03124 Version 4

## Warranty Extension: 2008–10 Accord SRS Unit

Supersedes 16-007, dated April 9, 2016 to revise the information highlighted in **yellow**

REVISED IMAGE

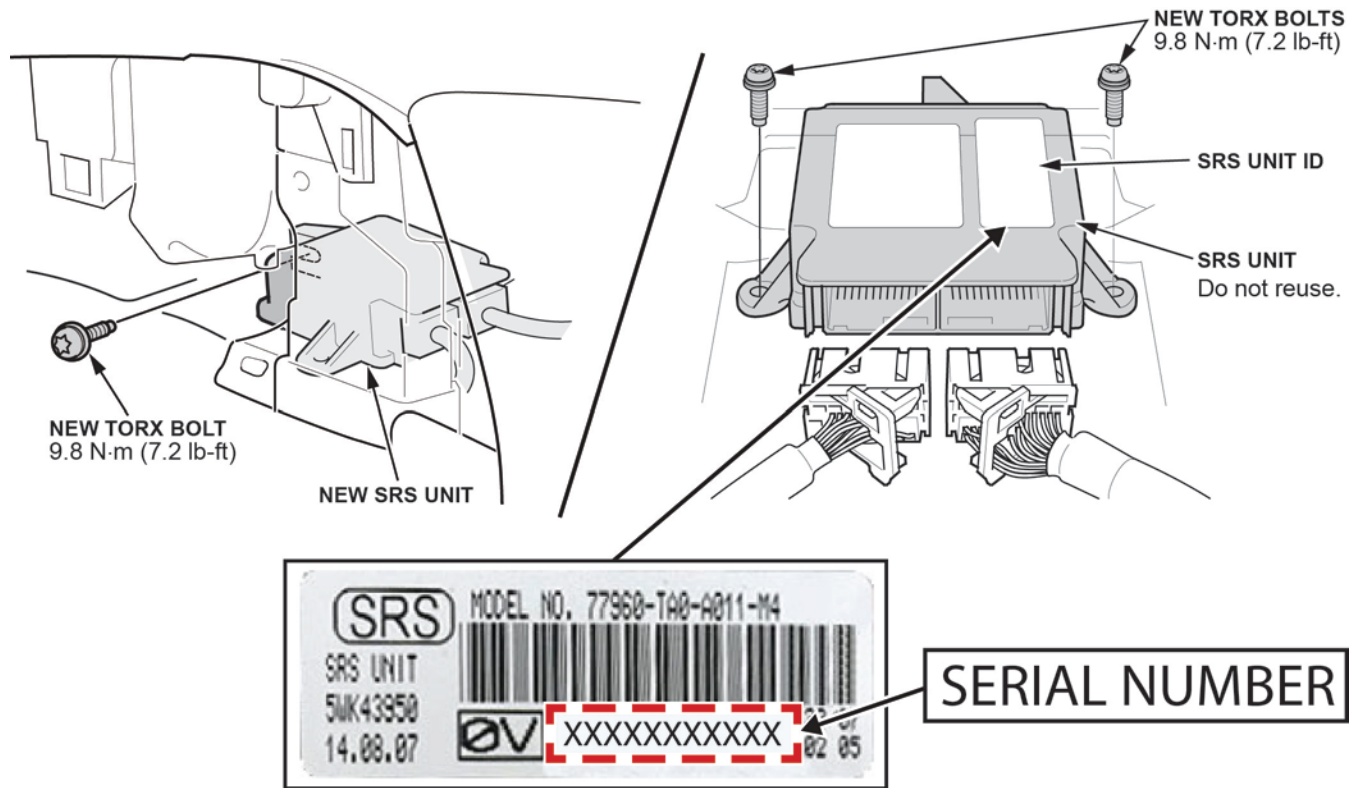
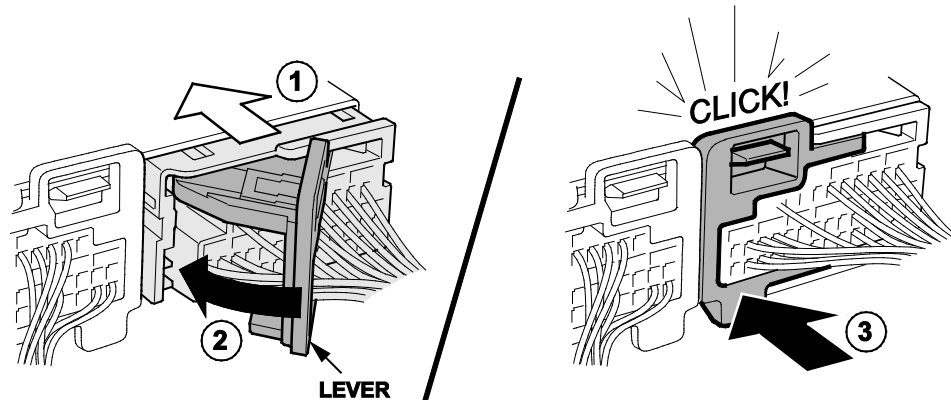
NOTE: Make sure the SRS unit is sitting squarely against its bracket before torquing the Torx bolts.
